Public Comment on 6279 Fernbank Development Applications and the Fernbank Creek Catchment Part 2
By Faith Blacquiere, Glen Cairn 20130821

APPENDIX A

Chronological Review of Fernbank Creek Catchment Development and Problems

Pg 4 [map rotated; blue = existing Phase 1, red = existing Phase 2A, yellow = existing Phase 2B, green = future Phase 3, purple = proposed]

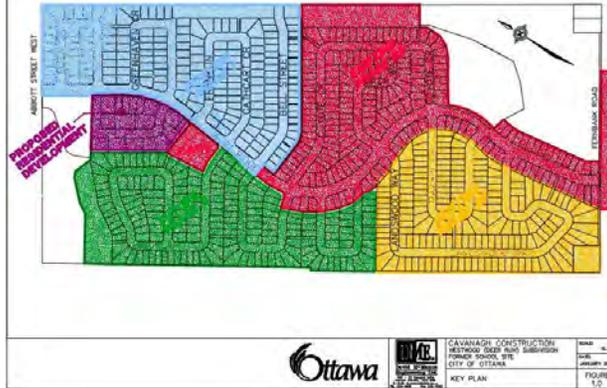
Why is 240 West Ridge Drive using 1280L/s when the others are using 1166L/s?

Elevations are similar to those proposed for the 6279 Fernbank development upstream of most of Westwood e.g. 6279 Fernbank Servicing Study Pg 42
